LOWER MINNESOTA RIVER WATERSHED DISTRICT

Executive Summary for Action

Lower Minnesota River Watershed District Board of Managers Meeting
Wednesday, December 16, 2020

Re: 77th Street Underpass Permit Review (LMRWD No. 2020-132)

Figure 1: 77th Underpass Project Location

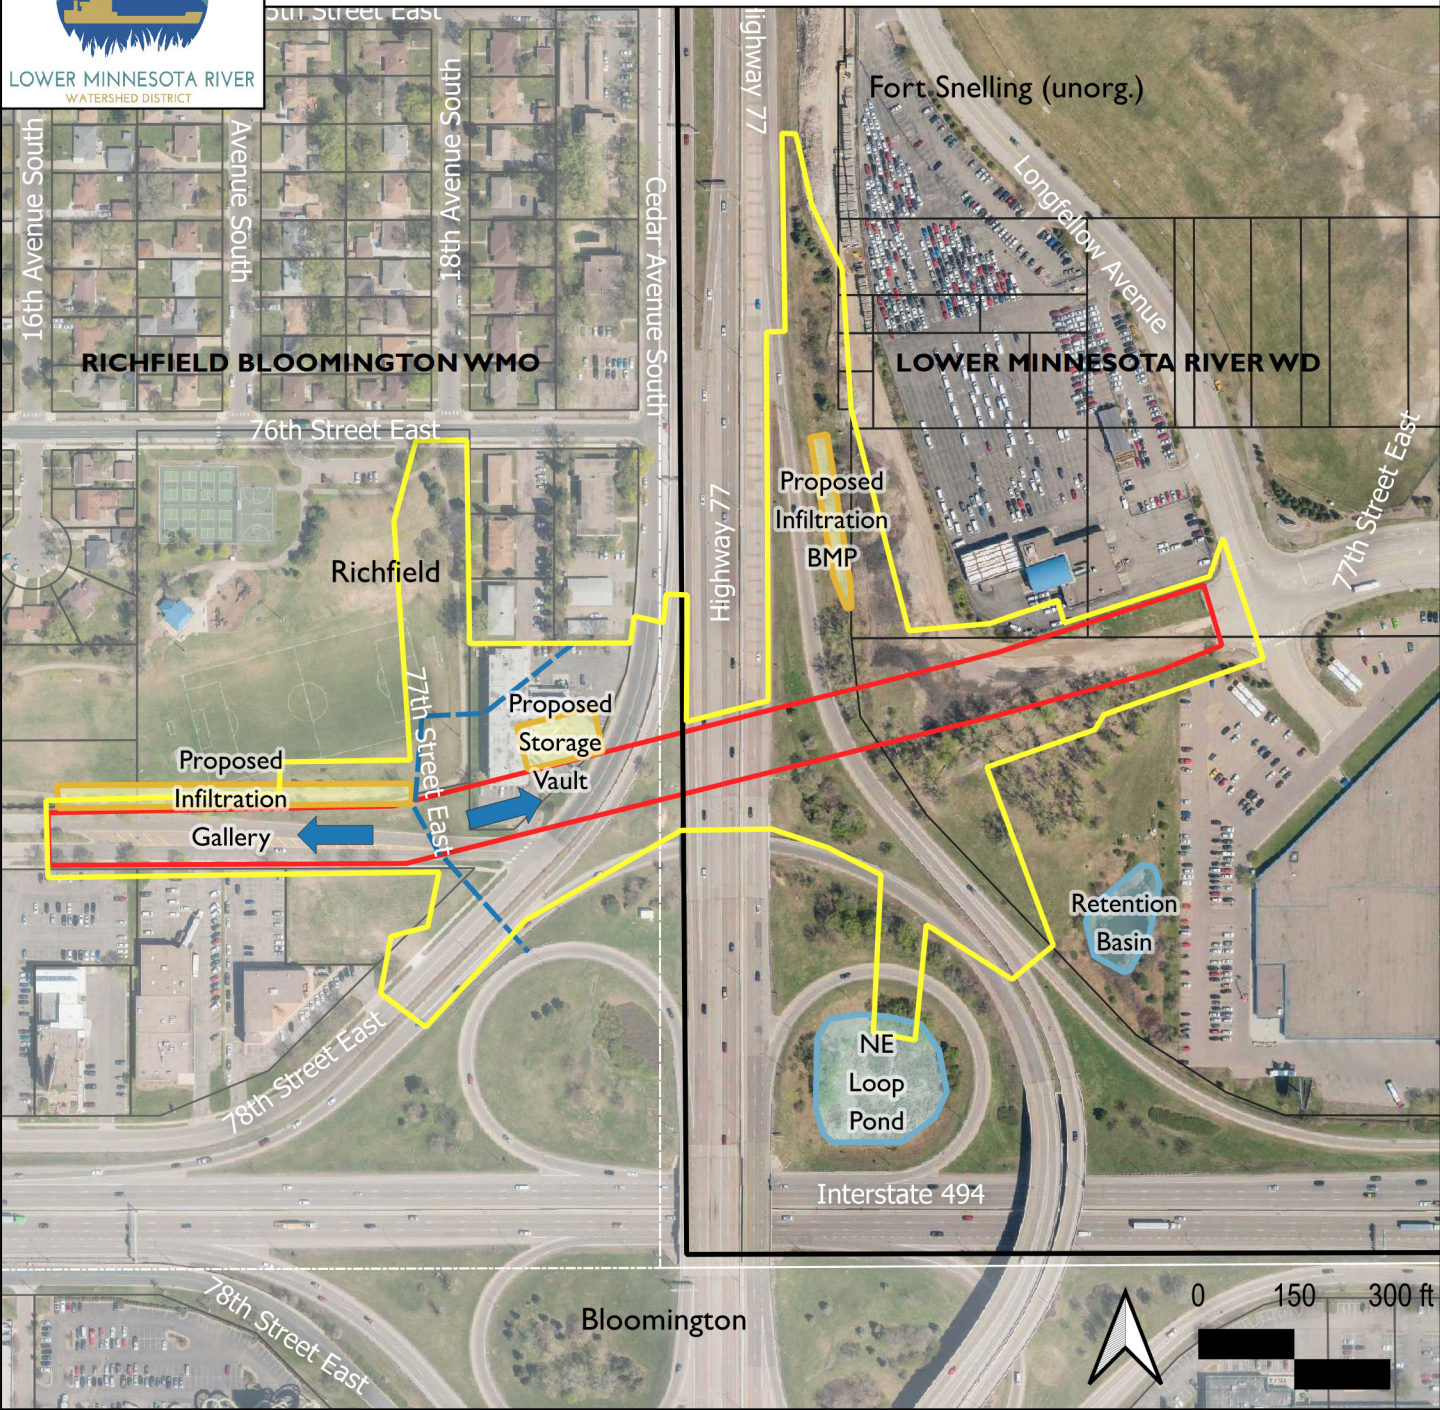
On November 24, 2020, WSB submitted a new design, which includes a small infiltration BMP located in the northeast quadrant of the TH 77 and I-494 interchange (**Figure 1**). This new BMP provides stormwater treatment for an area of TH 77 roadway that does not receive any stormwater treatment. This area of roadway currently flows to the same outlet as the new impervious from the proposed 77th Street Underpass. The BMP has an unconventional design that will require the contractor to “punch through” the restrictive clay layer by excavating three 4- by 8-foot funnels, backfilled with coarse aggregate, which will allow stormwater to infiltrate into the underlying sand layer.

Additionally, the project will change the watershed boundaries by redirecting surface area from RBWMO to LMRWD (**Figure 1**).

but proposed to be redirected to LMWRD) will provide flood storage and rate control. Runoff from the project will discharge into the existing NE Loop stormwater pond in the northeast quadrant of the TH 77–I-494 interchange, which overflows into the I-494 storm sewer (**Figure 1**). An underground infiltration system in Washington Park will reduce volume and improve water quality for the proposed impervious surface. However, stormwater treated by this system flows west, within the RBWMO boundary, and, thus, would not benefit the LMRWD. With the November 24, 2020, design revision, WSB has included a new infiltration BMP within the LMRWD boundary, which will provide volume reduction and water quality treatment.

As presented, with the addition of the new infiltration BMP within the LMRWD boundary, the proposed 77th Street Underpass now meets the District rules. We recommend conditional approval, pending receipt of the final NDPEs permit.

Figure 1: CSAH 11 Reconstruction Project Location

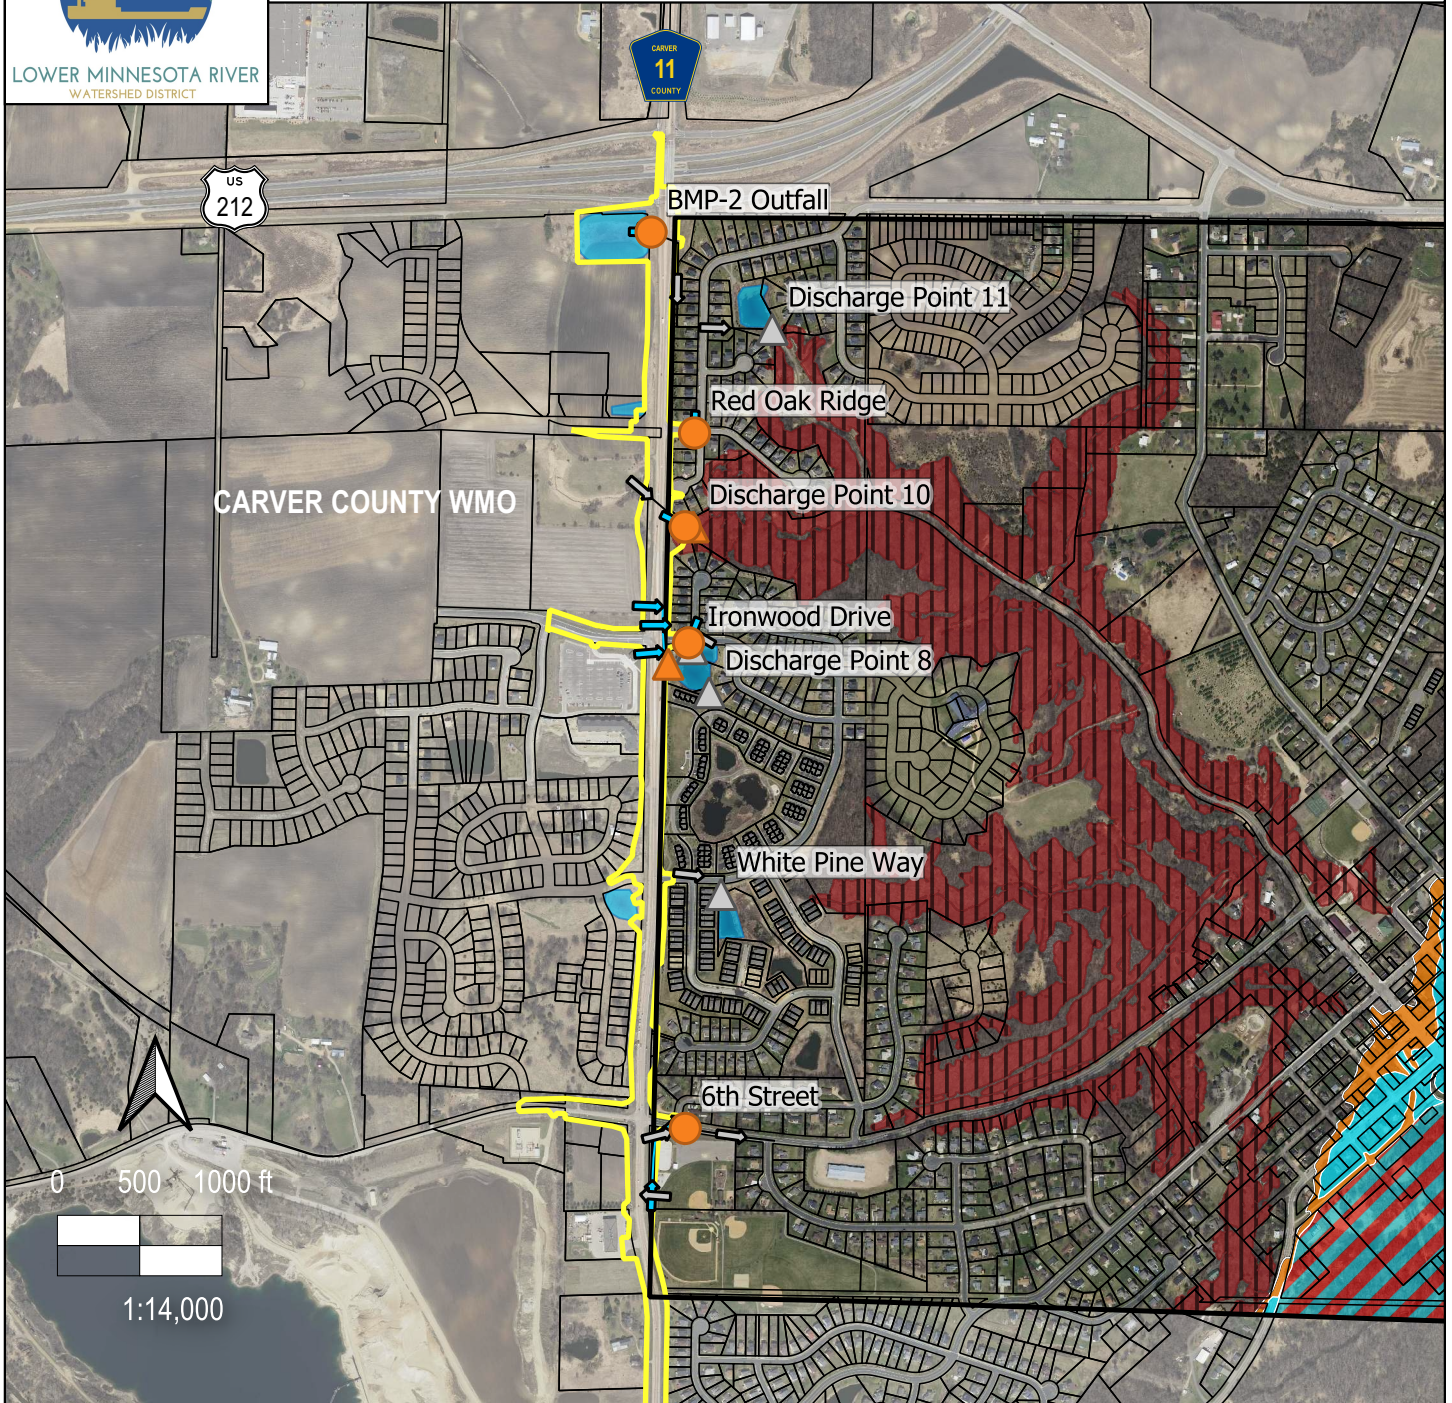
Comment 6: Provide additional information on how Discharge Point 10 would address existing erosion issues or prevent further gully erosion.

Comment: While the provided figure (Figure 2) helps clarify the proposed design, and we recognize the project is reducing flows at Discharge Point 10 (Table 1), supporting data such as exit velocities, scour calculations, and/or riprap design calculations are needed to determine how the project will address existing erosion issues or prevent further gully erosion. Provide the revised plans for Discharge Point 10 as well as the supporting design calculations that confirm the proposed outlet design will be stable and will not adversely affect the gully or steep slopes.

December 10, 2020 Response: Closed—WSB provided additional information, including the full-flow design velocity of 9.81 feet per second (fps) supporting proposed outfall protection design.
